TP193825 BACKSPACE MAGNET ASSEMBLY

APPARATUS AFFECTED: 28A, 28B, 28D, 28E, 28F, 28G, 28G-1, 28H, 28J, 28J-1, 28K, 28LA Perforator-Transmitter-Bases.

OBJECT: To provide more reliable operation and simplify adjusting procedure.

FIGURE 1. MANUAL AND POWER DRIVE BACKSPACE MECHANISM
FOR CHADLESS OR FULLY PERFORATED
TAPE (LATEST DESIGN)

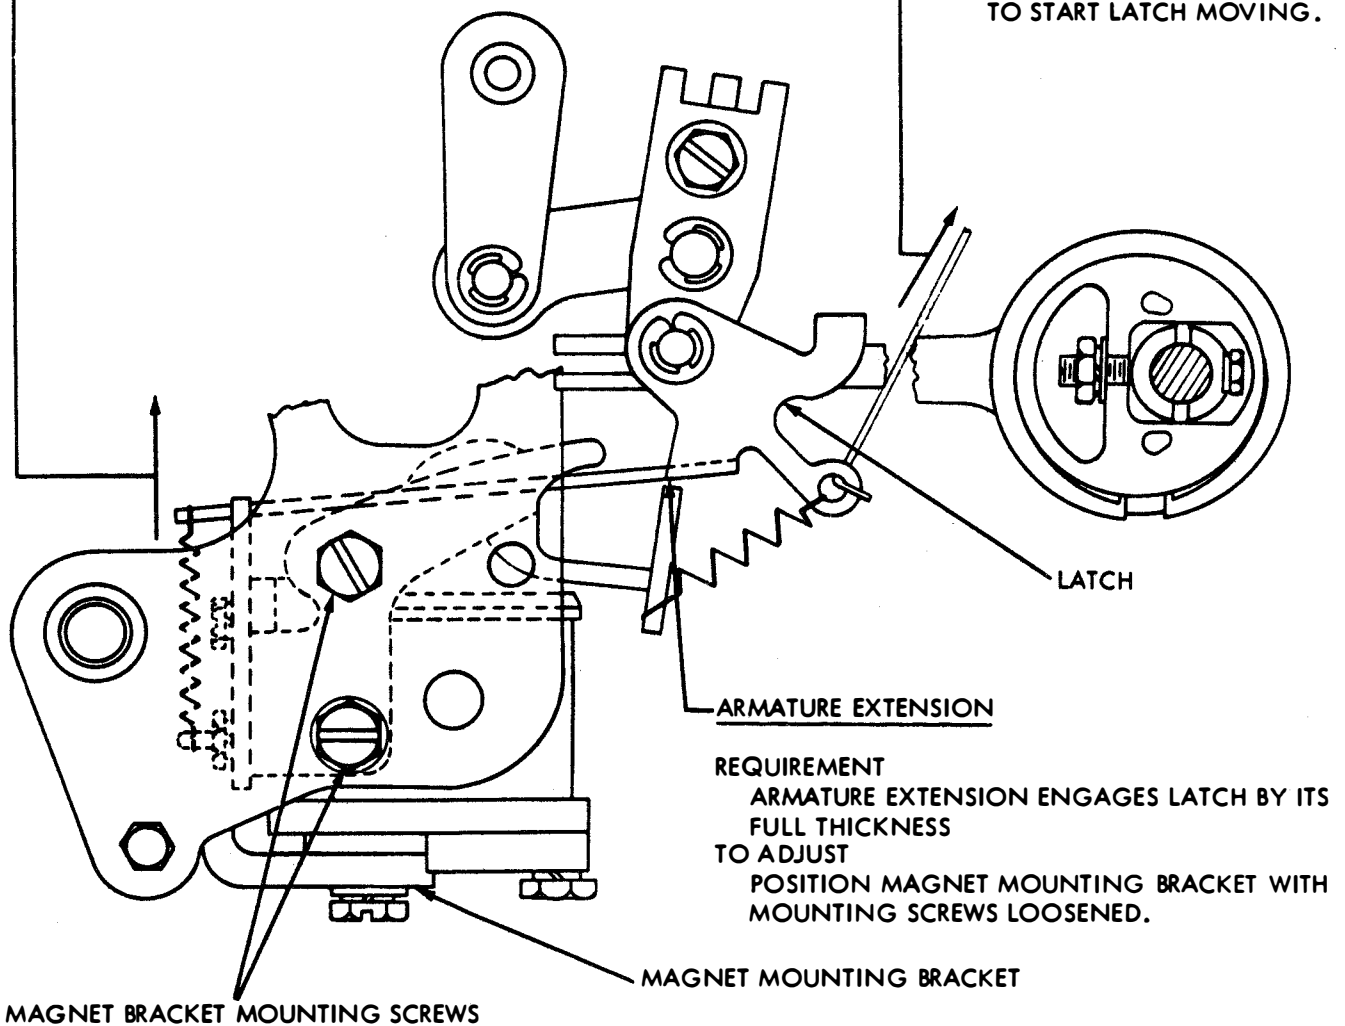
CHANGE: 1. The TP159966 backspace magnet assembly used in the backspace mechanism is replaced by the TP193825 backspace magnet assembly.

2. Requirement is added to Section 573-119-700, Section 573-118-700 and Section 573-117-700, after the last adjustment for the backspace mechanism.

See FIGURE 1.

ARMATURE SPRING

REQUIREMENT
MIN 15 OZS
MAX 20 OZS
TO PULL SPRING TO INSTALLED LENGTH.

LATCH EXTENSION SPRING

REQUIREMENT
MIN 1 OZ
MAX 2-1/4 OZS
TO START LATCH MOVING.
